City of Greenville

Planning Commission

4:00 PM March 17, 2022

**Planning Staff Report to
Greenville Planning Commission
March 11, 2022
for the March 17, 2022 Public Hearing**

PRELIMINARY
PLAT - 1

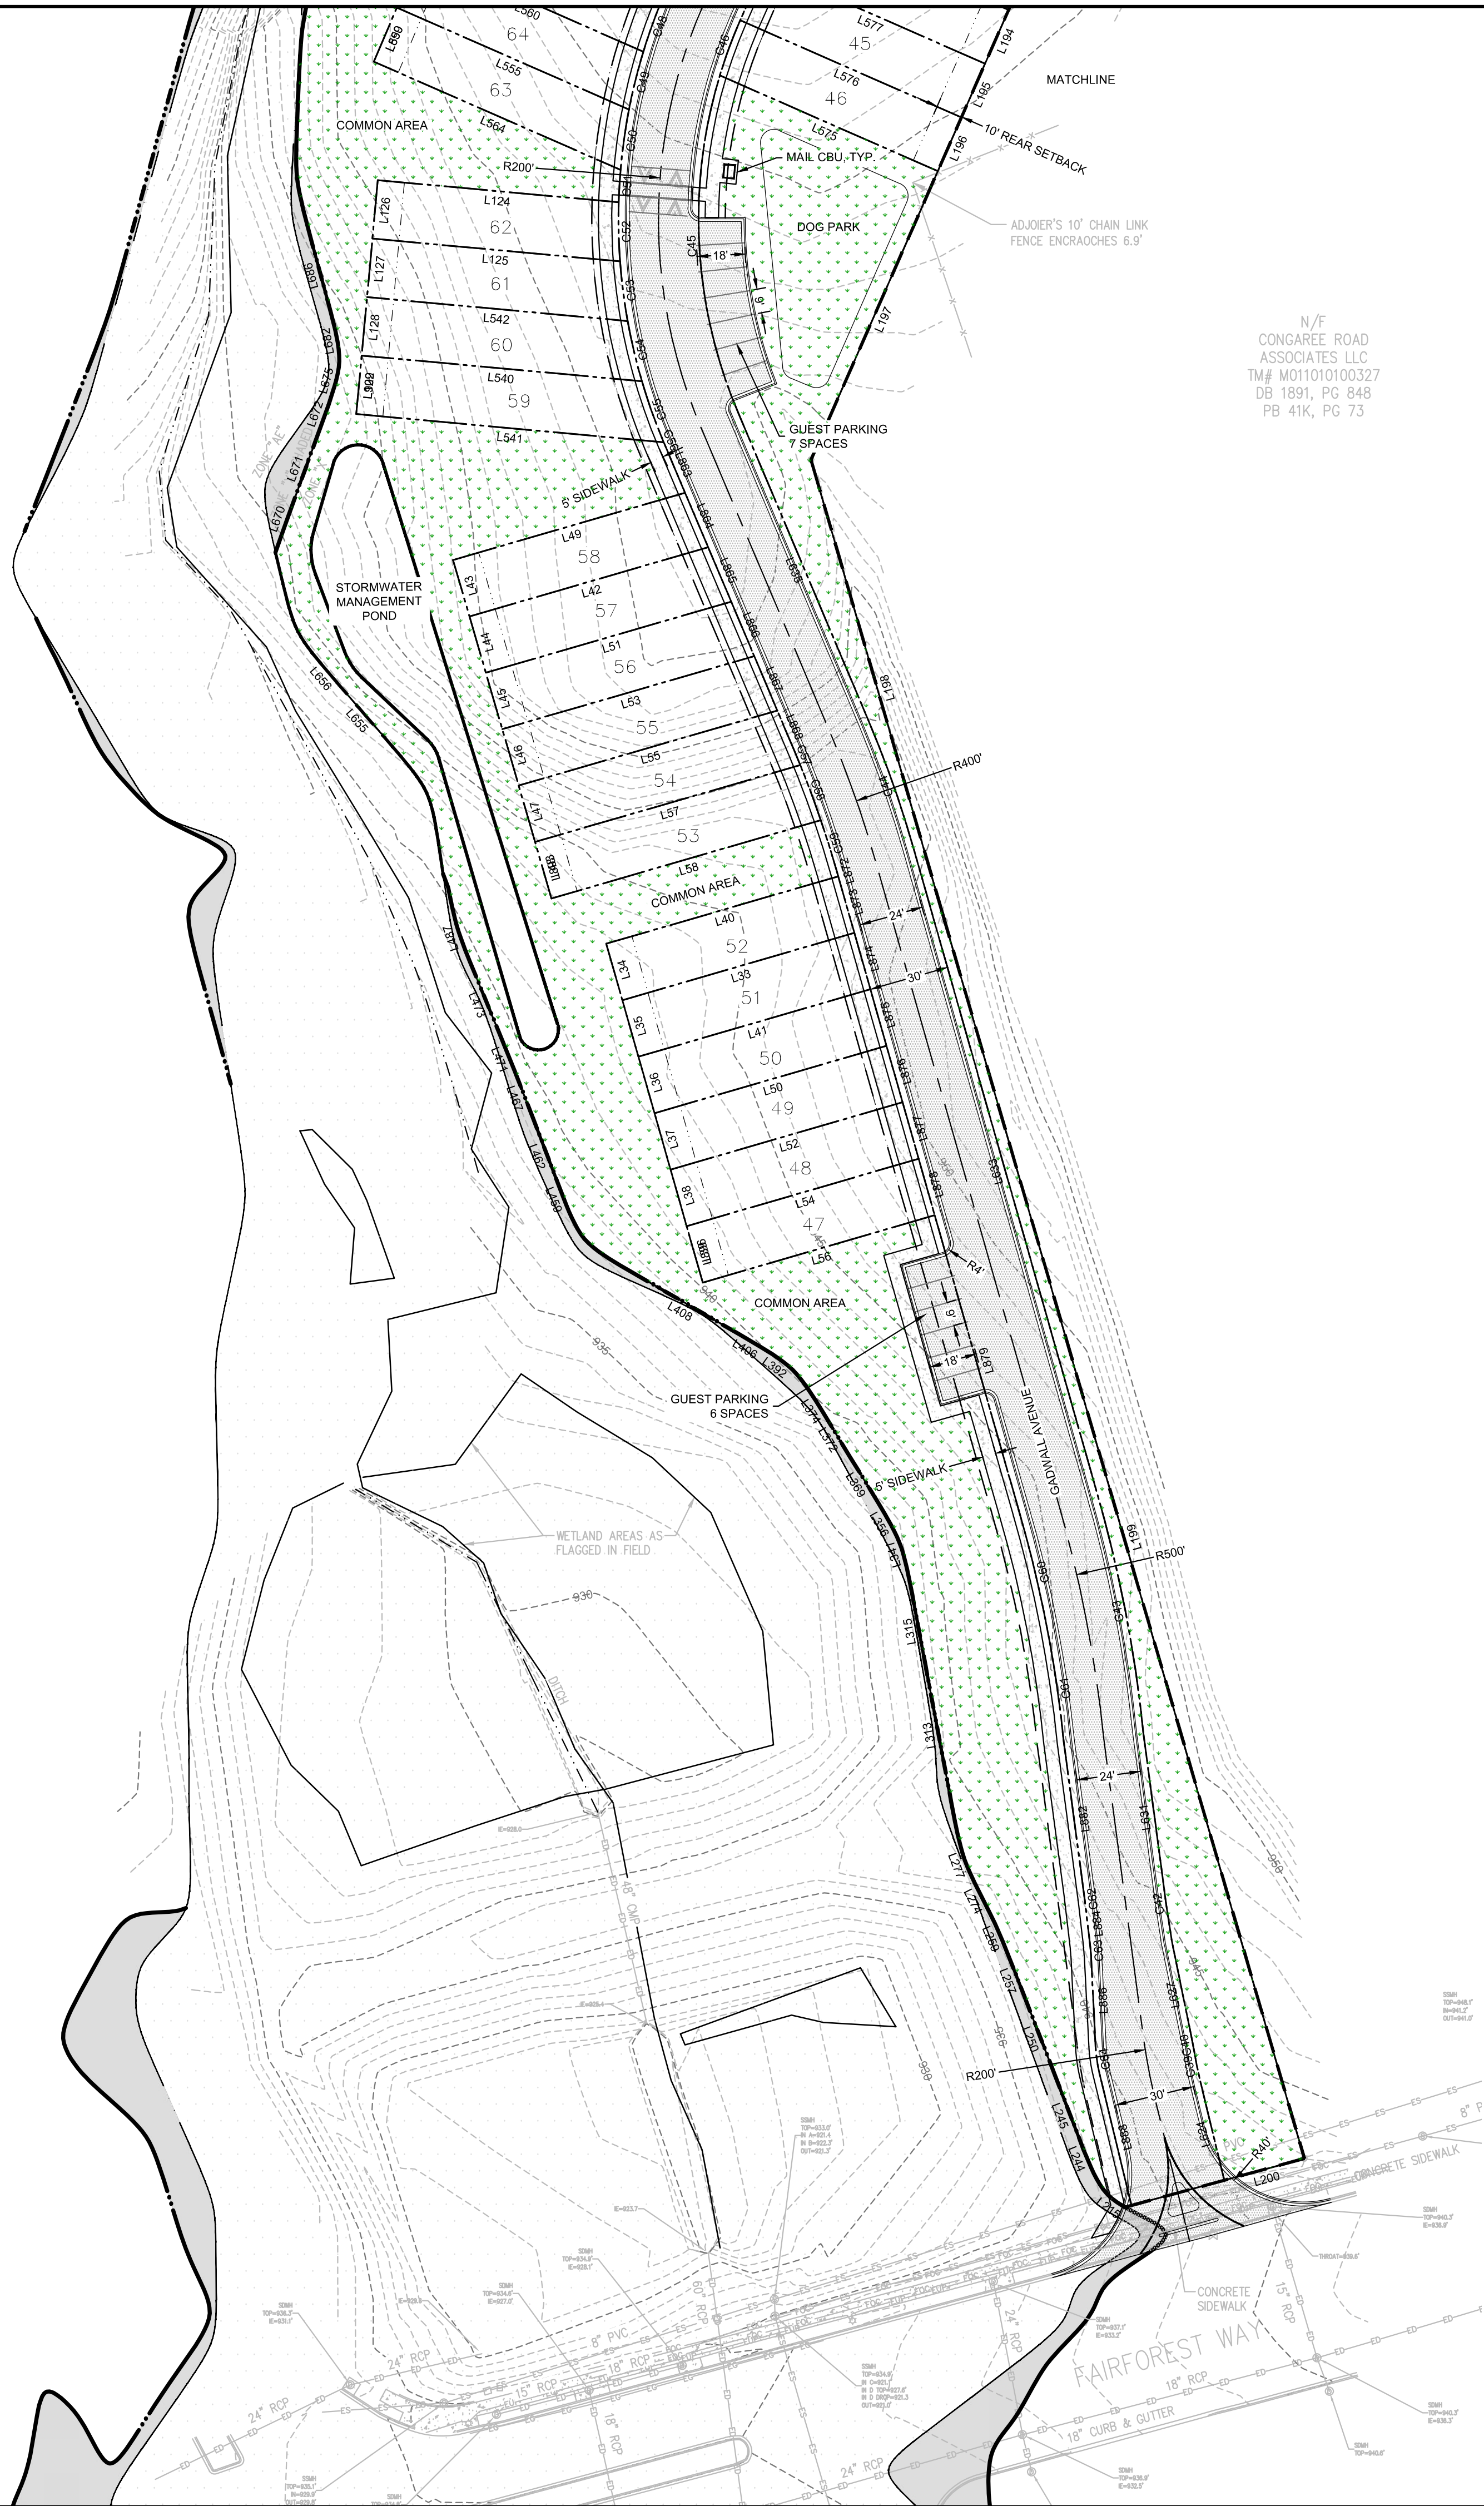
The conceptual location of units on the plan provide evidence that a compliant layout that conforms to applicable dimensional standards, for single-family attached residences, is feasible. Requirements to replace the hammerhead on the south end of Muscovy Trail necessitates a reconfiguration of lots to accommodate a cul-de-sac, and dimensional standards will similarly apply to those lots.

The roadways throughout the development are planned to be private. The roads are proposed at a width of 24 feet from face-of-curb to face-of-curb, but through Civil Engineering Department conditions are required to be 28 feet in width. Pavement widths will need to be adjusted accordingly. The hammerhead turnaround at the south end of Muscovy Trail does not comply with the City's Design and Specification Manual, and will need to be replaced with a cul-de-sac. Civil Engineering Staff is confident this can be handled during the site plan permit review process. To maintain activation of Ridge Road, installation of an offset cul-de-sac should be offset towards the interior of the property.

- 8) On the southeast side of Muscovy Trail, the two hammerhead road configurations will not be allowed. A cul-de-sac will be required to be built; therefore, the townhome layout in this area will need to be modified.
- 9) The typical section provided does not meet the City's standard. The road will need to be a minimum of 28 feet in width (face of curb to face of curb).
